Re: GVRE Filing 18 (#1571504)/Pre-Application Meeting held September 02, 2021

On behalf of Oakwood Homes and Terracina Design, we have reviewed the comments dated September 15, 2021. The following is a response to comments.

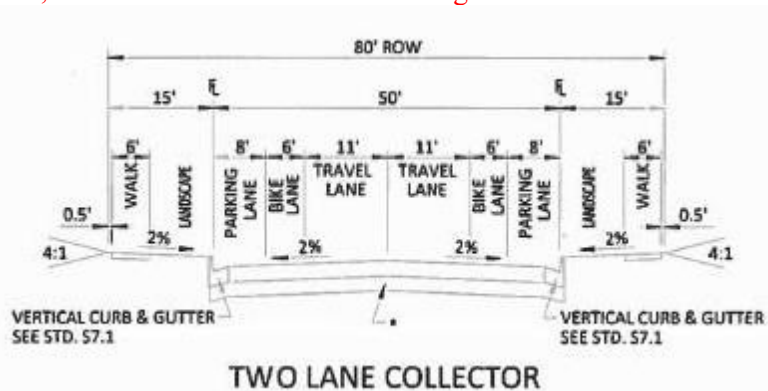
Double frontage lots shall not be permitted adjacent to local or collector streets and shall be avoided to the maximum extent practicable along arterial streets (Section 146-4.3.10.C). Where double frontage lots along arterial streets cannot be avoided, buffering of back yards from those streets shall include a landscaped buffer at least 20 feet in width between the rear lot line of any residential lot and the closest edge of the curbside landscaping area adjacent to the street, per Section 146-4.7.3.

The proposed plan includes lots that back to Tibet Road, which is classified as a collector. You are encouraged to re-work the plan to minimize the number of double fronted lots. **RESPONSE: This has been worked thru in Filing 15.**
